SOLICITATION AMENDMENT
MODIFICATION DE L'INVITATION

Title - Sujet Food Service Bldg Westmorland Inst	
Solicitation No. - N° de l'invitation EC016-141832/A	Amendment No. - N° modif. 003
Client Reference No. - N° de référence du client EC016-141832	Date 2014-01-17
GETS Reference No. - N° de référence de SEAG PW-\$PWB-020-3350	
File No. - N° de dossier PWB-3-36100 (020)	CCC No./N° CCC - FMS No./N° VME
Solicitation Closes - L'invitation prend fin at - à 02:00 PM on - le 2014-01-23	Time Zone Fuseau horaire Atlantic Standard Time AST
F.O.B. - F.A.B. Plant-Usine: <input type="checkbox"/> Destination: <input type="checkbox"/> Other-Autre: <input type="checkbox"/>	
Address Enquiries to: - Adresser toutes questions à: Donovan, Janine PWB	Buyer Id - Id de l'acheteur pwb020
Telephone No. - N° de téléphone (506) 636-5347 ()	FAX No. - N° de FAX (506) 636-4376
Destination - of Goods, Services, and Construction: Destination - des biens, services et construction:

Addenda numéro 3

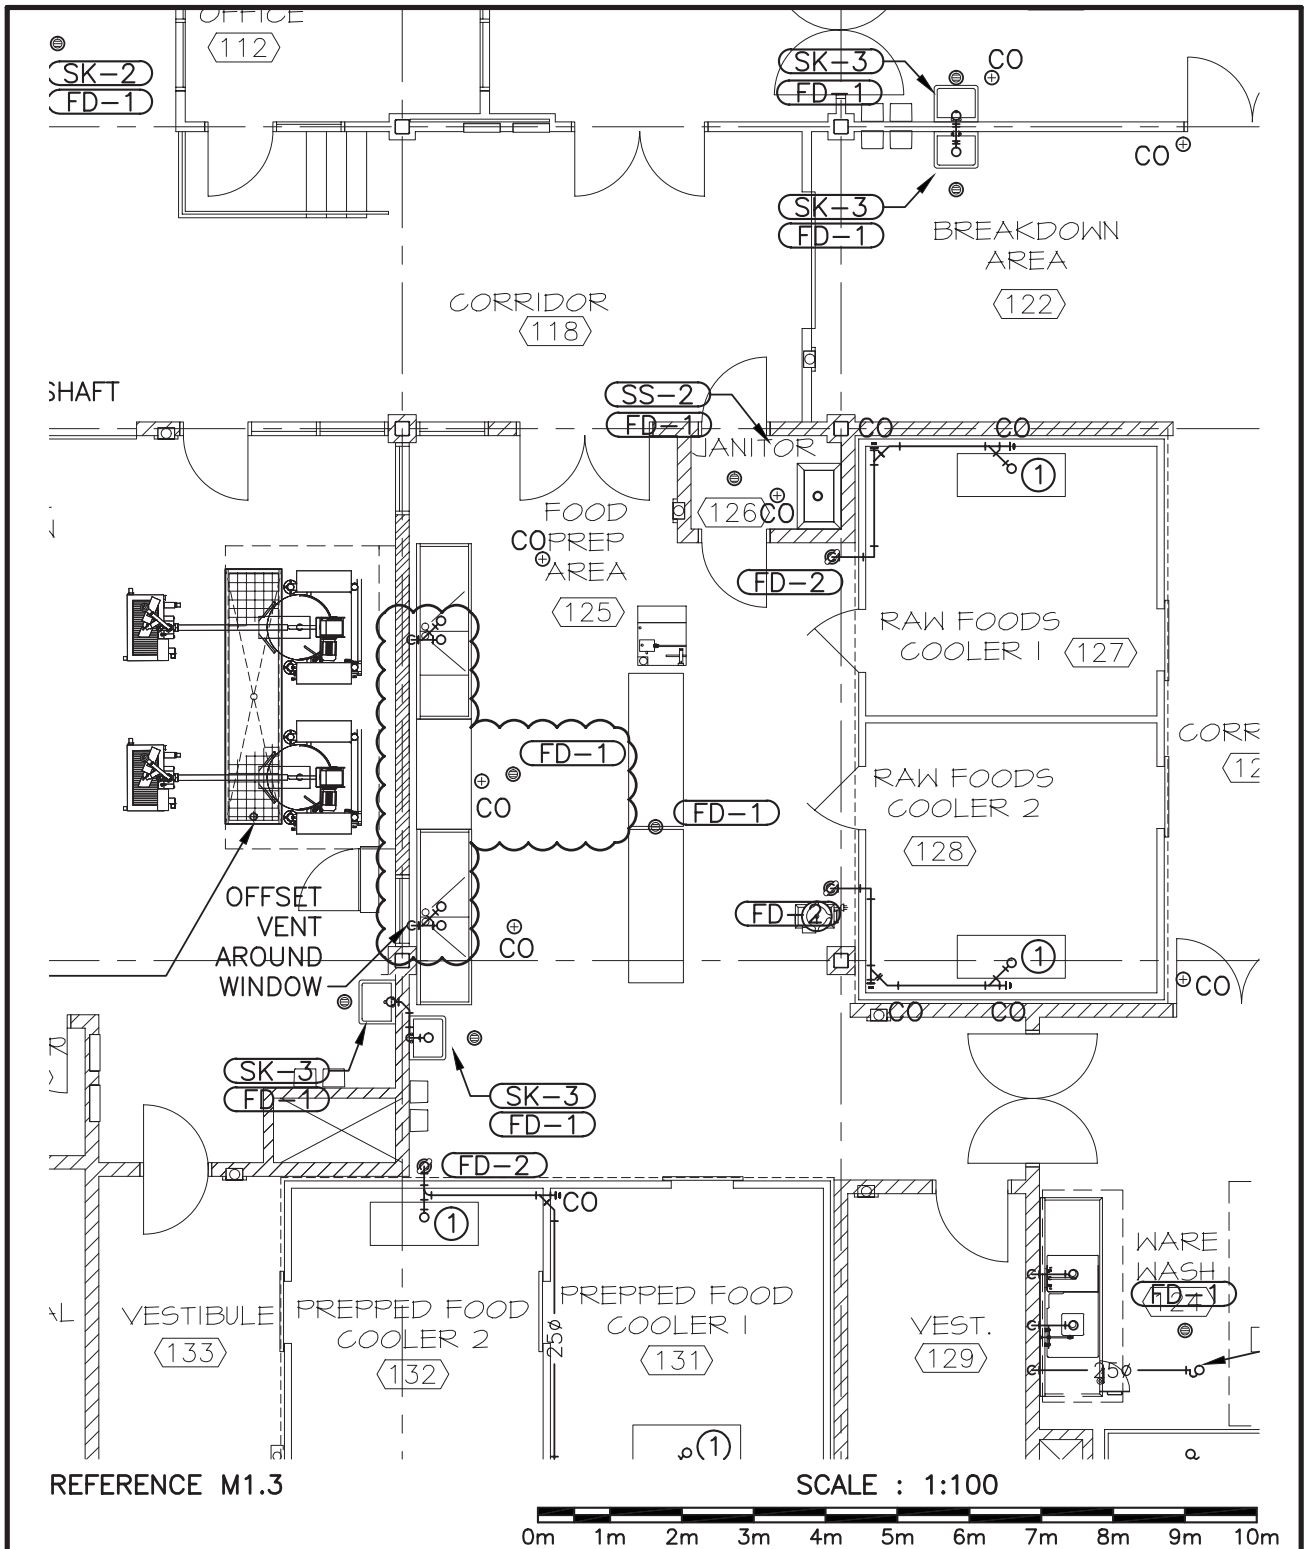
1. Provide sanitary piping and relocated floor drain for new kitchen equipment sink as indicated on attached MSK-3.

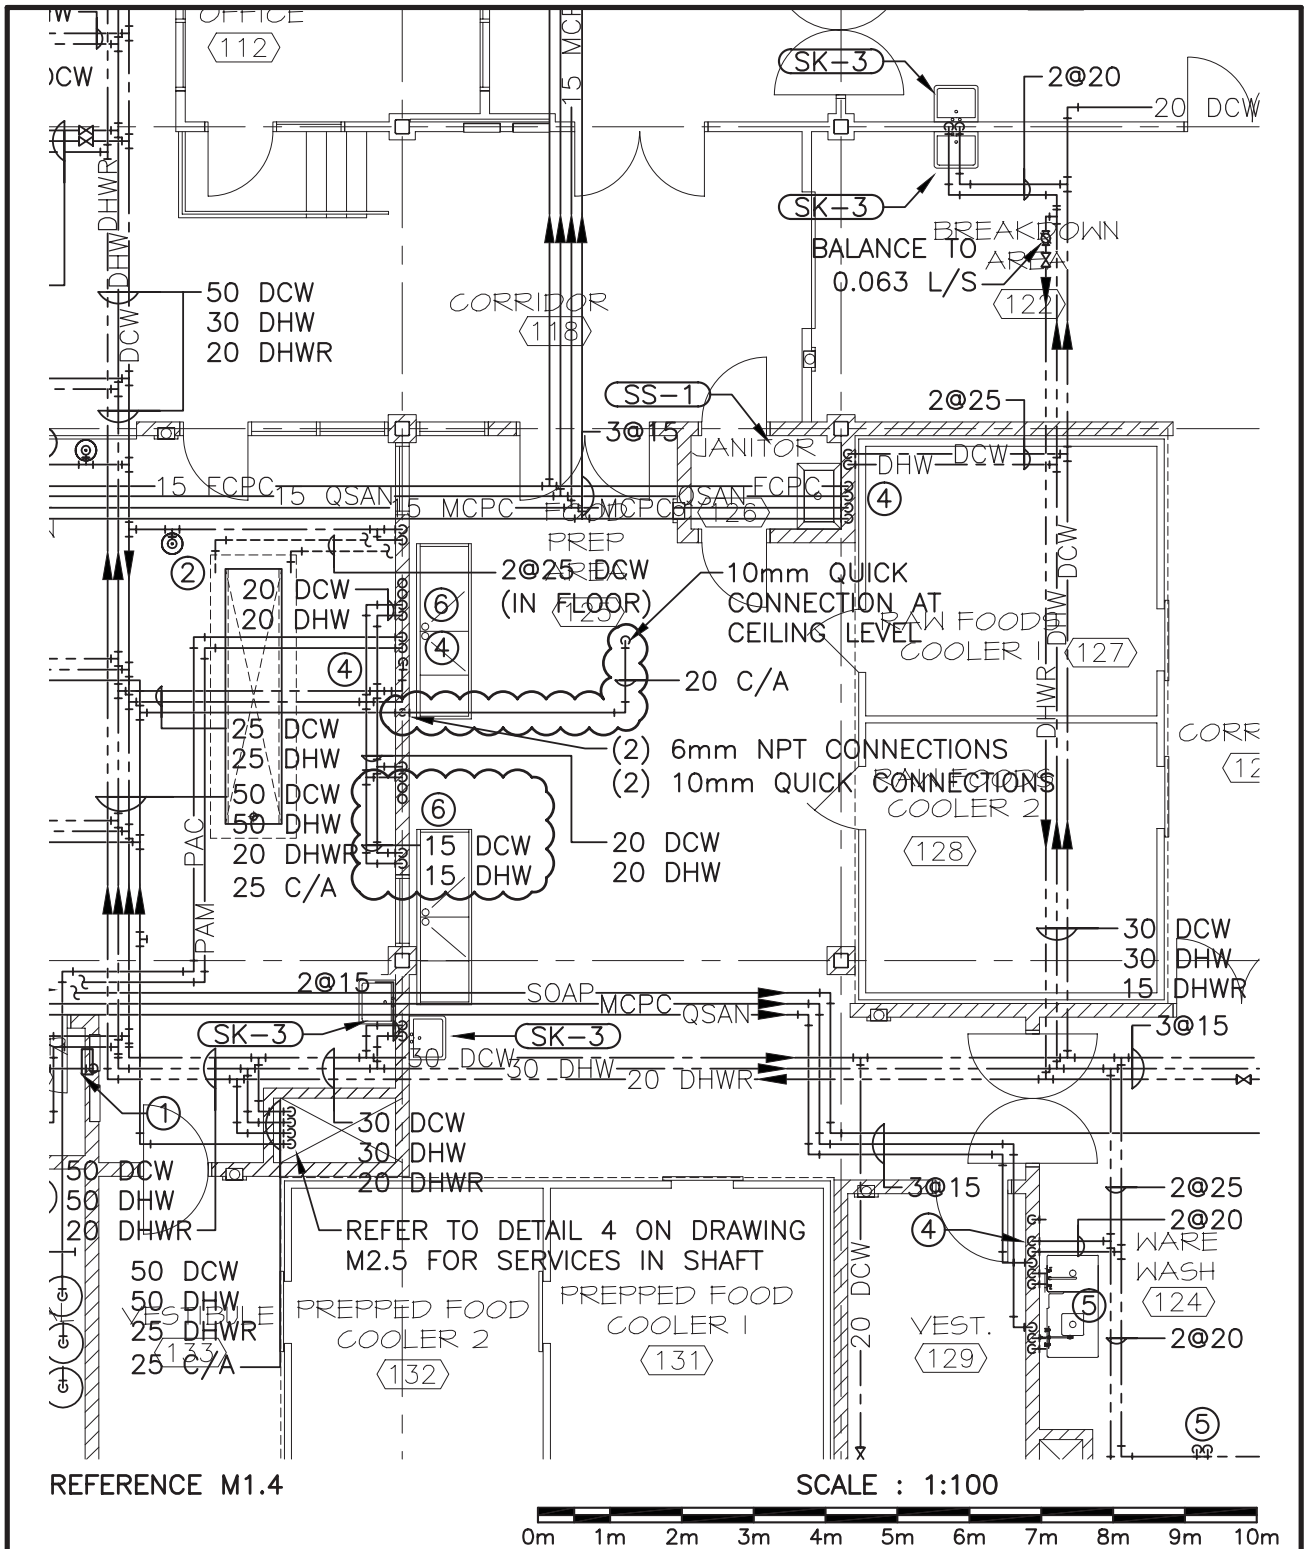
1. Provide water service to new kitchen equipment sink as indicated on attached MSK-4.
2. Revise compressed air as indicated on attached MSK-4.
3. Add plumbing for chemicals as indicated on attached MSK-1.
